**Rutland County Council**

Application:	<b>2019/0614/FUL</b>	<b>ITEM 1</b>	
Proposal:	<b>Erection of a freestanding restaurant with drive-thru facility, car parking, landscaping and associated works, including Customer Order Displays (CODs).</b>		
Address:	<b>Land Off, Lands End Way, Oakham, Rutland</b>		
Applicant:	<b>McDonald's Restaurants Ltd</b>	Parish	<b>Oakham Town Council</b>
Agent:	<b>Mr Matthew Carpenter, Planware Ltd</b>	Ward	<b>Barleythorpe</b>
Reason for presenting to Committee:	<b>Departure from the Adopted Local Plan</b>		
Date of Committee:	<b>14 January 2020</b>

DESIGN BY JK CHECKED BY JK DRAWING NO. 7499-SA-8681-P004 N  
SCALE & SIZE 1:200@A1 DATE Feb 2019

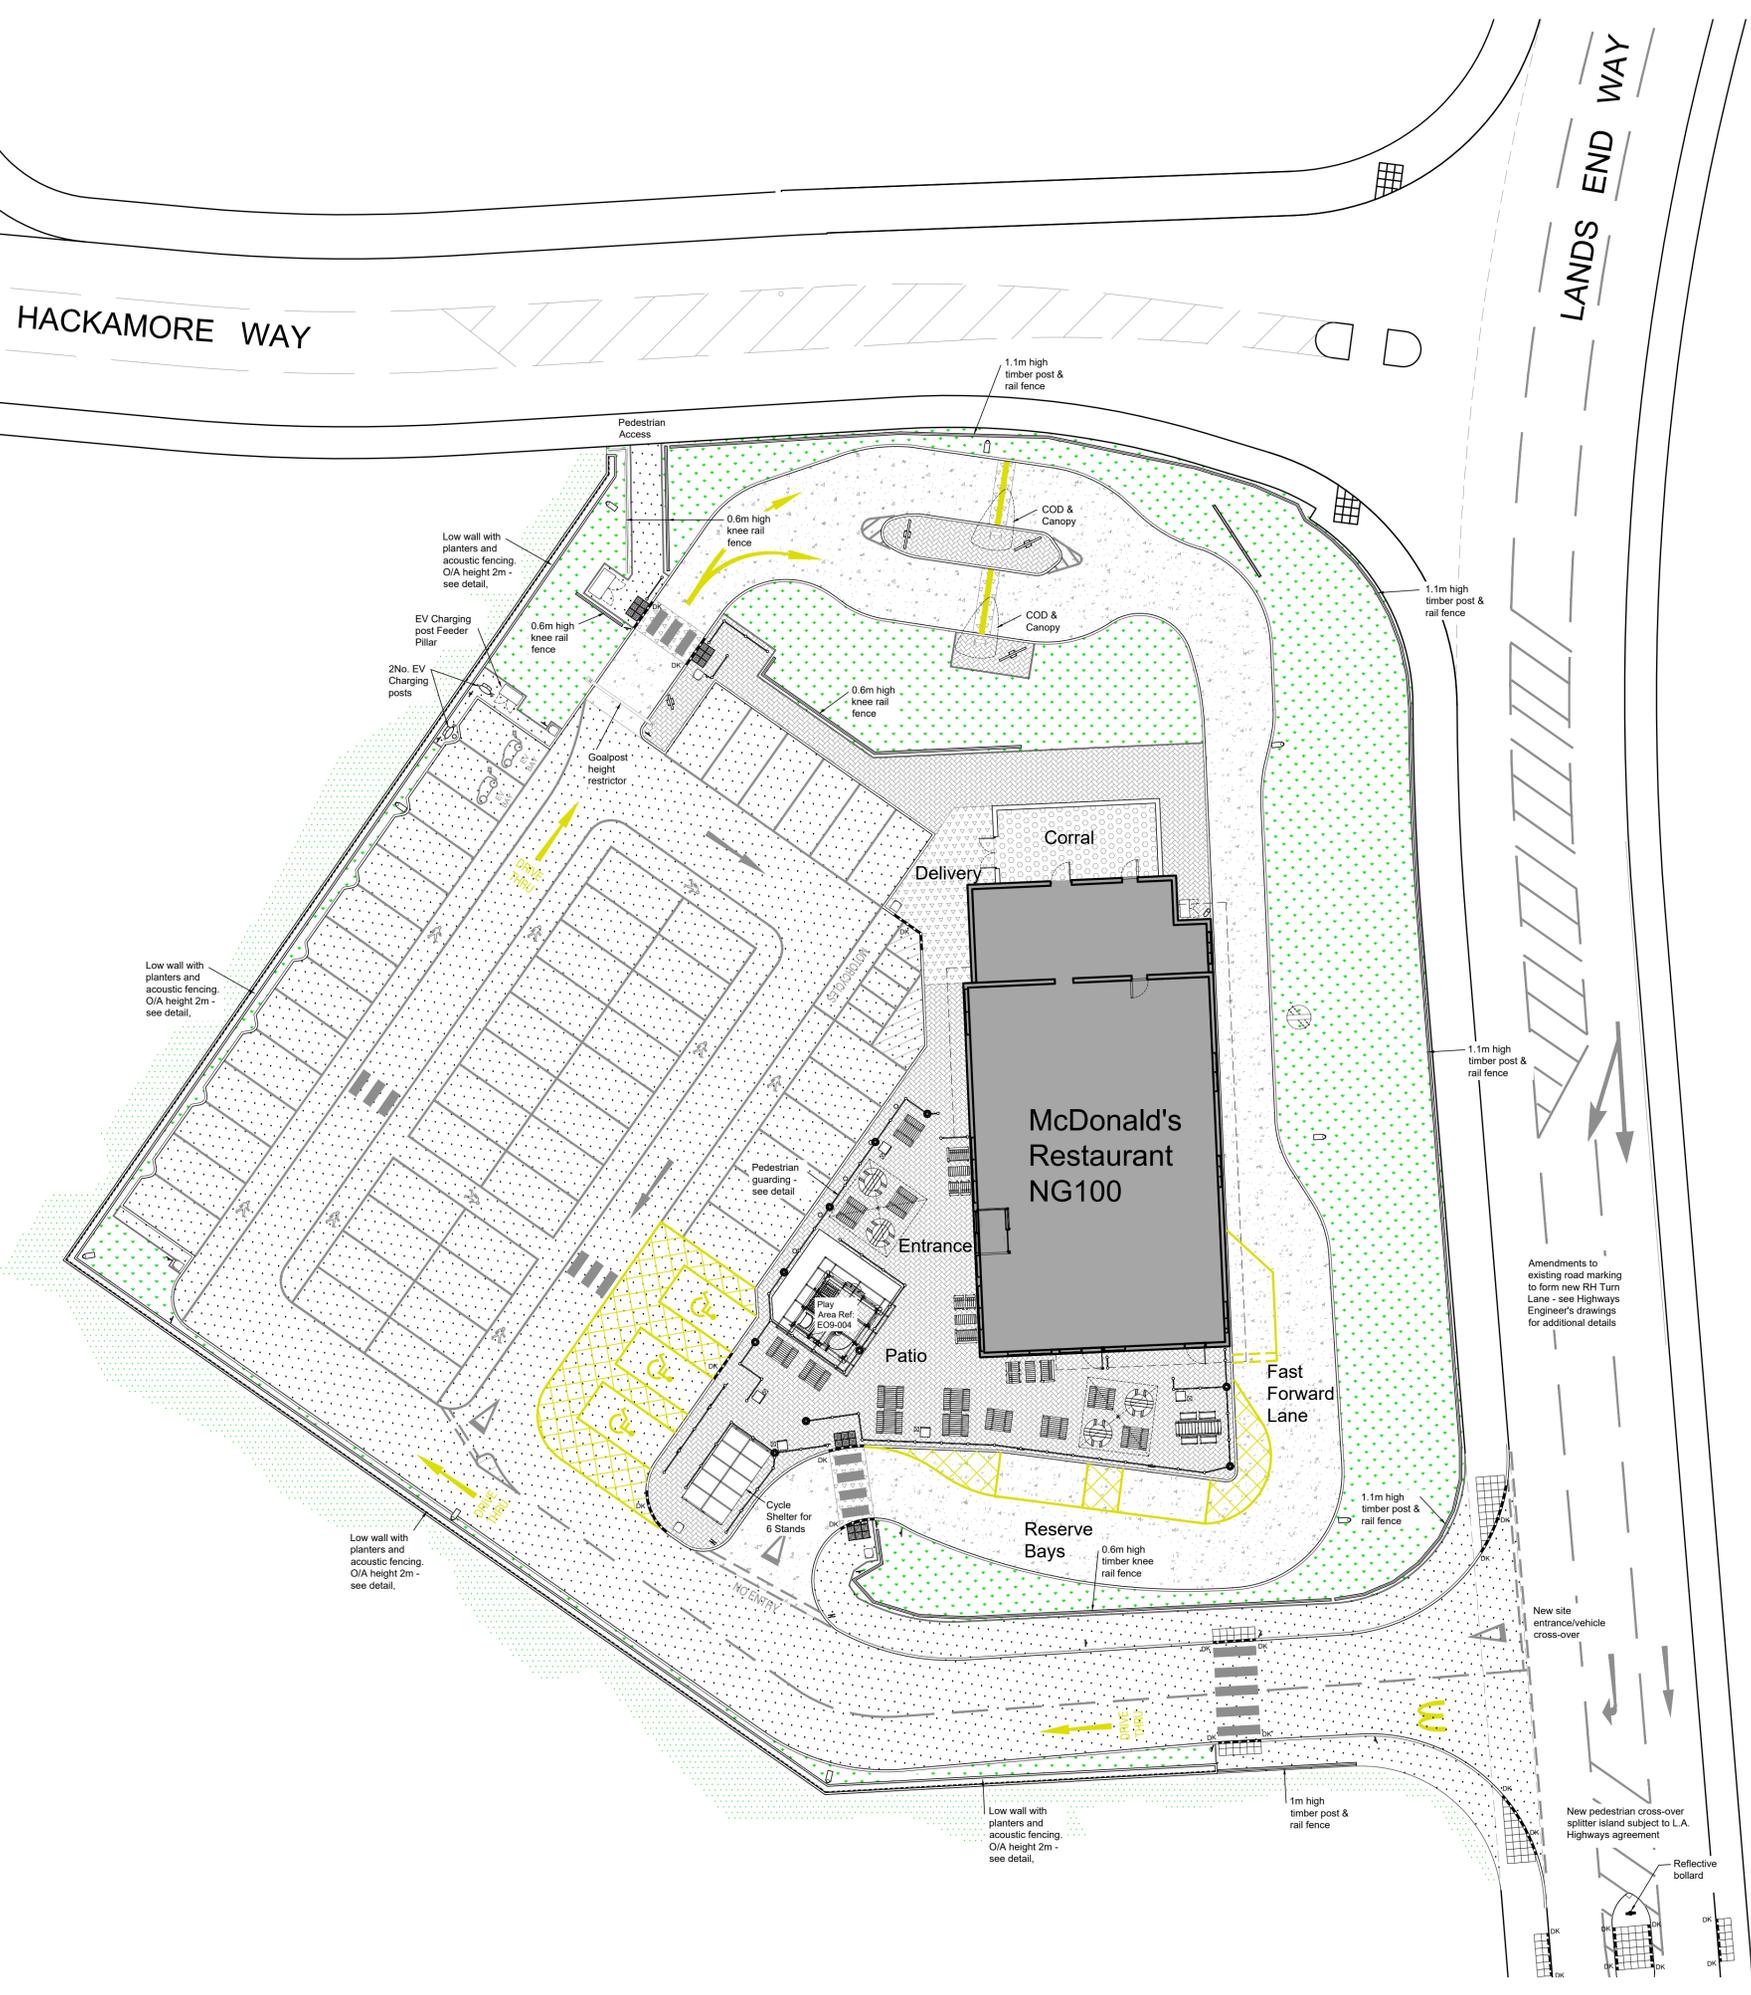
I am satisfied that the applicant has provided sufficient methodology in relation to their parking standards and staffing levels. Therefore I have no Objections if built in accordance with drawing - 7499-SA-8681-P004M Site Layout Plan.

- Increased parking from 8 to 12 bicycles is welcomed, however no reference has been made to our request for a canopy. If McDonalds are committed to reducing car travel by their employees, covered cycle parking will be essential - to protect bikes from rain. We would request a clear canopy be provided here.
- We would welcome further consideration regarding the location of cycle parking. At present the suggested railings would allow cyclists to cut across the drive through exit. Instead, subject to the developers own assessment of safety, we question whether the railing would be better sited as per the red line in the attached plan, with a dropped kerb in the approximate location of the green line, and the actual shelter (with canopy) (blue line) moved back to the railings.

We would welcome further consideration regarding the location of cycle parking. At present the suggested railings would allow cyclists to cut across the drive through exit. Instead, subject to the developers own assessment of safety, we question whether the railing would be better sited as per the red line in the attached plan, with a dropped kerb in the approximate location of the green line, and the actual shelter (with canopy) (blue line) moved back to the railings.

43. As submitted the proposal only provided 2 disabled parking bays. During negotiations the applicant has agreed to increase this to 3 bays to comply with the Council's adopted standards as per the Site Allocations and Development Plan Document adopted in 2014. In addition following feedback from the drop-in session held at Brightways at Catmose Park further revised drawing were submitted. These showed the relocation of the play space to allow minor alterations to the disabled spaces, setting them slightly forward, and thus allowing better ramped access to the rear of vehicles.

REV.	DATE.	DRAWING REVISIONS.	BY.	CHECKED
N	25.11.2019	Updated to suit latest signage proposals.	NCC	
M	01.12.2019	Boundary treatment revised.	JK	
L	11.02.2019	Boundary treatment revised.	JK	
K	18.10.2019	Changes to cycle shelter amended. Parking bays and boundary treatment revised.	JK	
J	28.09.2019	Cycle shelter and guarding added.	JK	
I	12.08.2019	Parking bays and patio layout revised.	CP	
O	28.07.2019	Signage added to Lands End Way updated.	DM	
F	25.07.2019	EV charging bay notes updated.	JK	
E	19.07.2019	Accessible parking and cycle parking increased. EV bays revised.	JK	
D	19.06.2019	Pass door to South entrance and Canopies amended. IT Lane road markings updated.	JK	
C	05.06.2019	Public consultation amendments.	JK	
B	22.03.2019	ADL Tracking amendments.	JK	
A	20.03.2019	PLANNING ISSUE	JK
